# OLDHAM POND DAM

NJ 00238

## PHASE 1 INSPECTION REPORT NATIONAL DAM SAFETY PROGRAM

OLDHAM POND DAM (NJ00238)

FIGURE 1

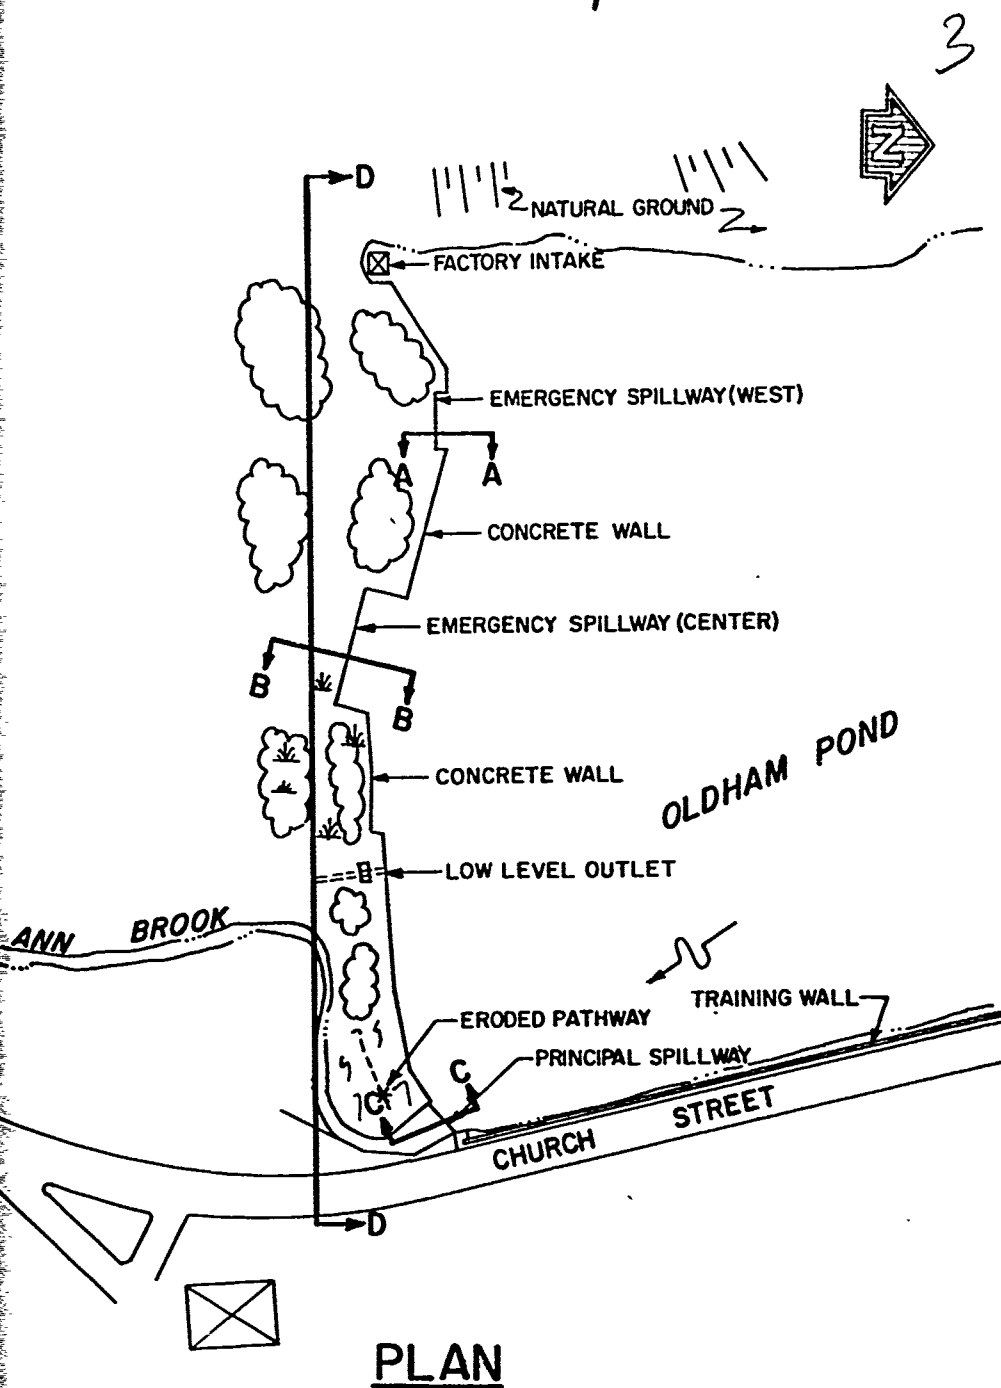
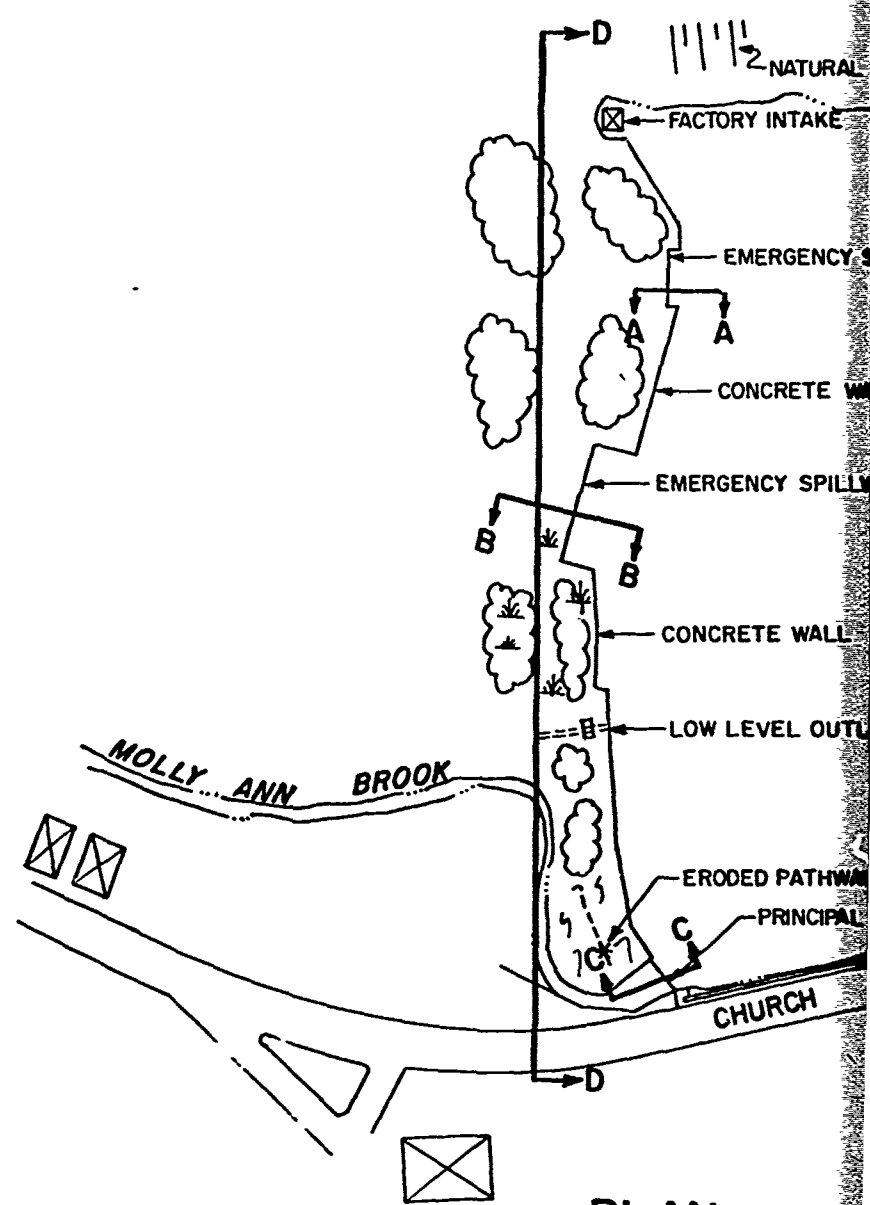
VISUAL EXAMINATION OF	OBSERVATIONS	REMARKS OR RECOMMENDATIONS
SEEPAGE OR LEAKAGE	West Emergency Spillway-Minor leakage along joint of concrete ogee. Center Emergency Spillway-Minor leakage at masonry joints and underneath masonry downstream wall.	Repair the horizontal construction joints in west emergency spillway face. Investigate minor leakage through foundation.
STRUCTURE TO ABUTMENT/EMBANKMENT JUNCTIONS	See Sheet 2 of " Embankment Dams "	
DRAINS	Center Emergency Spillway-None observed West Emergency Spillway-None observed	
WATER PASSAGES	Center Emergency Spillway-None Observed West Emergency Spillway-None Observed	
FOUNDATION	Center Emergency Spillway-Foundation not visible West Emergency Spillway-Foundation not visible

VISUAL EXAMINATION OF	OBSERVATIONS	REMARKS OR RECOMMENDATIONS
SURFACE CRACKS	None observed. Sinkhole filled with concrete at break in alignment of upstream wall. Wall cracked at location of sinkhole	Repair wall and sinkhole
UNUSUAL MOVEMENT OR CRACKING AT OR BEYOND THE TOE	None observed	
SLOUGHING OR EROSION OF EMBANKMENT AND ABUTMENT SLOPES	Brush cover on downstream slope makes it impossible to inspect it adequately	Remove brush and conduct inspection of slope
VERTICAL AND HORIZONTAL ALIGNMENT OF THE CREST	Surface of crest is quite uneven. Horizontal alignment is good.	
RIPRAP FAILURES	No riprap	Provide upstream slope protection
